CERTIFICATE OF APPROPRIATENESS

Property: 501 Highland Street, Lot 16, Block 9, Woodland Heights Subdivision. The property includes a historic 1,654 square foot two story residence and two story garage-apartment situated on a 5,000 square foot (50' x 100') corner lot.

Proposal: Alteration – Addition *Revision*.

WEST SIDE ELEVATION

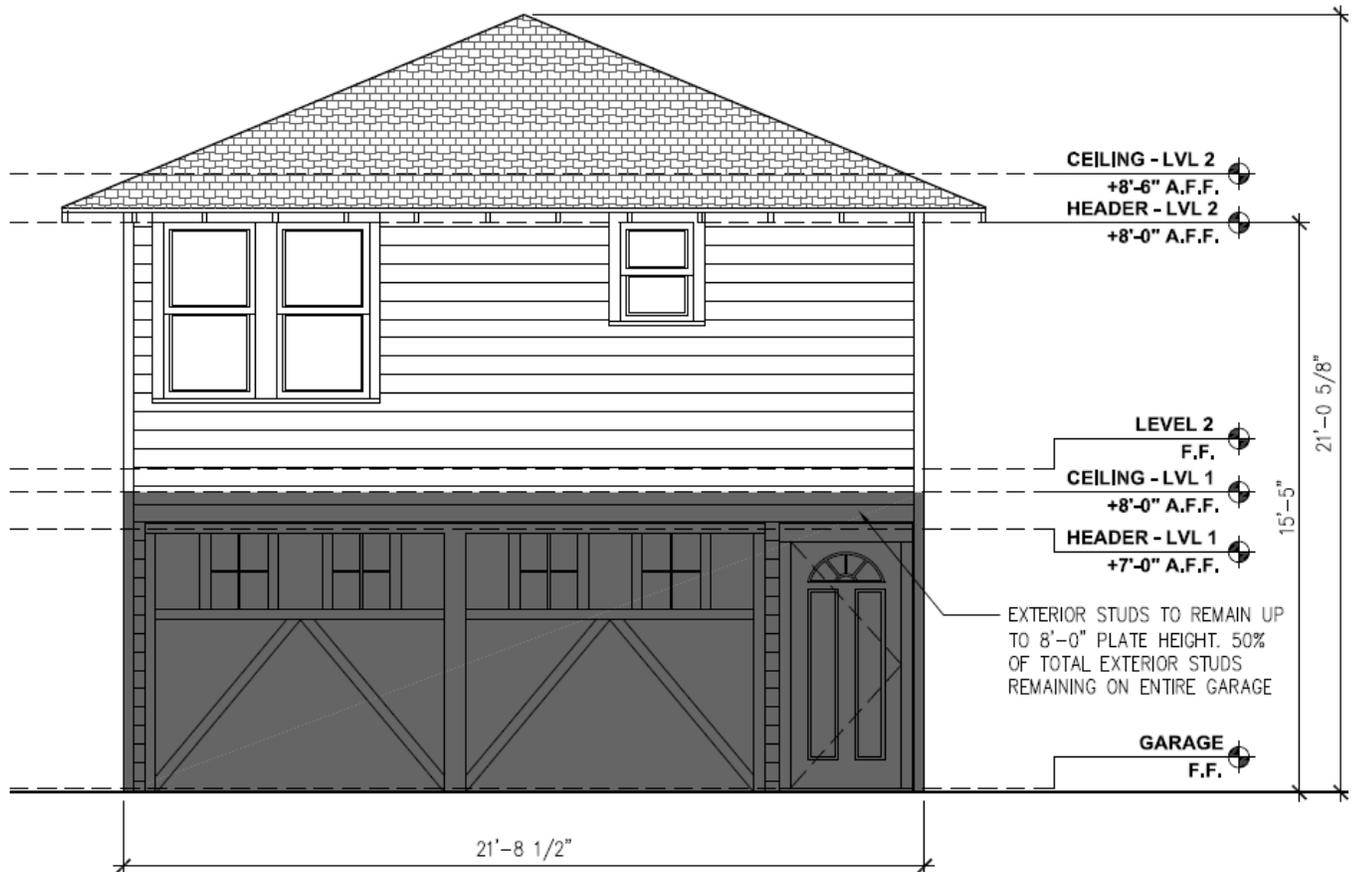
- The builder has once again violated the approved scope of work by increasing the height of the garage from 21' to 24' without permits or COA approval. The work was performed in March 2016 but hidden from city staff by the builder and designer, who used old lumber to disguise the alterations. 'Before' and 'after' photos received in September provided concrete evidence to staff that the builder had in fact altered the garage height without permits.

Shape/Mass: The original garage was to remain and not be altered. However, as part of the addition, the garage was to be connected to the proposed rear addition. The approved unaltered garage was to retain an eave height of 15'-9" and ridge height of 21'-4³/₄".

According to the builder, the garage elevation was modified to accommodate several structural and architectural inaccuracies that are common when attaching two separate buildings with different elevations. Ultimately, due to these modifications, the garage walls were raised approximately 2'-8³/₄" or somewhere between 3 and 4 feet. The current garage has an eave height is 18'-5³/₄" and ridge height 24'-1 3/8". See drawings and photos for more detail.

STAFF PHOTOS (COMPARISON OF TOP PLATE)

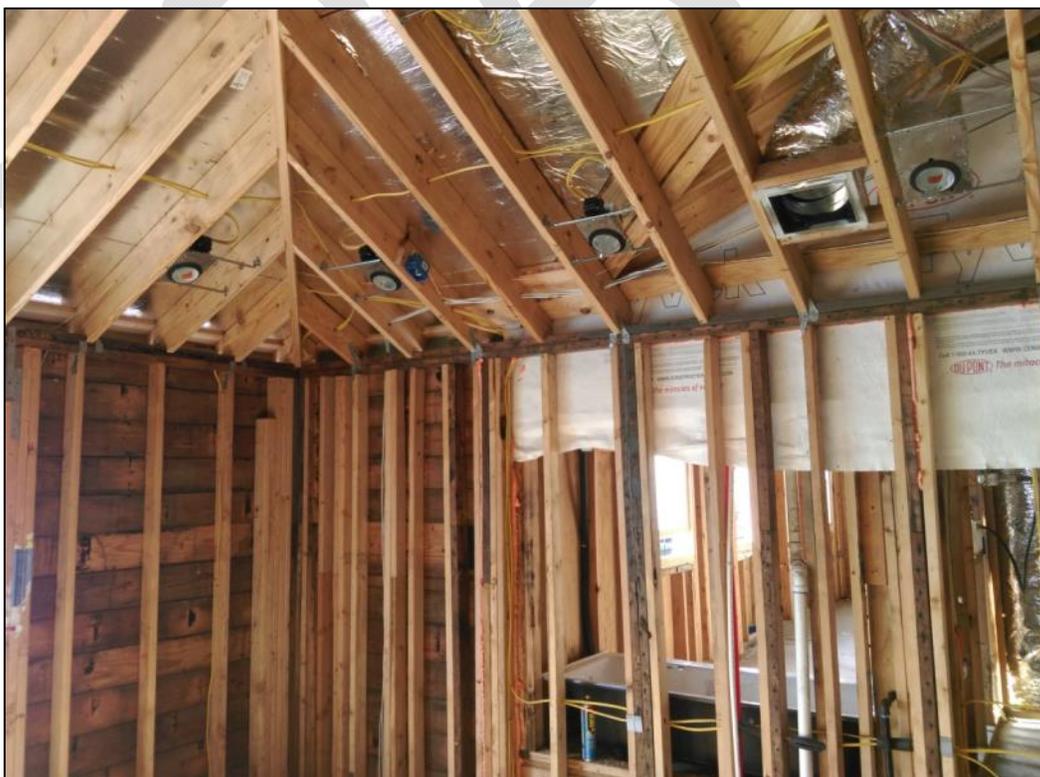
- September 2016 Staff continued to receive neighborhood complaints of unpermitted alterations. After further photo documentation was received by staff, staff was able to determine that that the builder had in fact raised the garage height by 3’-4’ without permits (the 21’ height shown in the original plans had been correct, despite Mr. McFarland’s information to the contrary). The photo documentation, showing the garage before and immediately after the builder raised the garage height, indicates that the work was done in late March 2016. The builder, Clark Arnold, eventually admitted that he had in fact knowingly increased the garage wall height by 3’ using old lumber to disguise the change from city staff. The purpose of the increase was to facilitate a structural connection between the existing garage and the new addition. While the roof was removed in March, an additional 3’ of wall height was added. Original studs were sandwiched between new lumber, and old siding from other parts of the garage was used to create a virtually seamless wall.

DEED RESTRICTIONS REQUIRE A 45' SETBACK FROM THE CENTER OF THE STREET

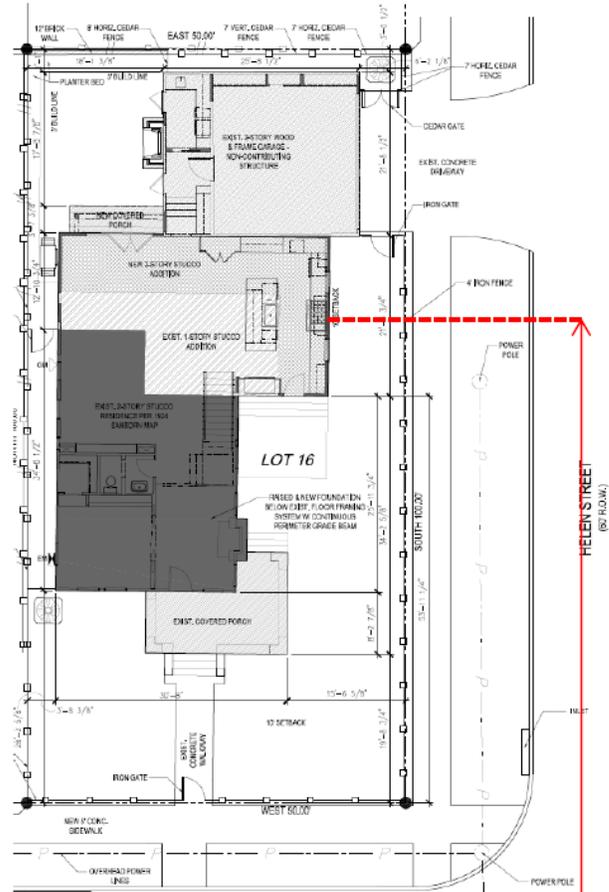
Existing residence set back 46.6' from the center of the street. 16.6' from the east property line which is 30' from the center of the street.

Proposed addition set back 40' from the center of the street. 10' from the east property line which is 30' from the center of the street.
